**Economic and Social Council**Distr.: General
1 August 2012

Economic Commission for Europe**Inland Transport Committee****World Forum for Harmonization of Vehicle Regulations****158th session**

**1958 Agreement – Consideration of draft amendments
to existing Regulations submitted by GRE****Proposal for Supplement 4 to the 01 series of amendments to
Regulation No. 98 (Headlamps with gas-discharge light
sources)****Submitted by the Working Party on Lighting and Light-Signalling***

Figure 1

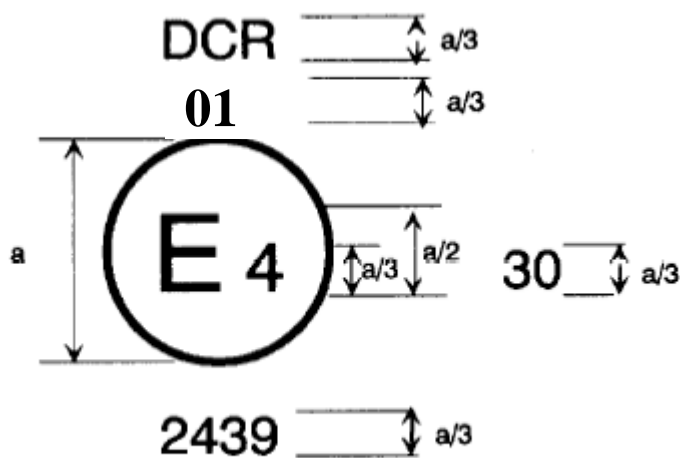
Annex 2, amend to read:

$a \geq 8$ mm (on glass)

$a \geq 5$ mm (on plastic material)
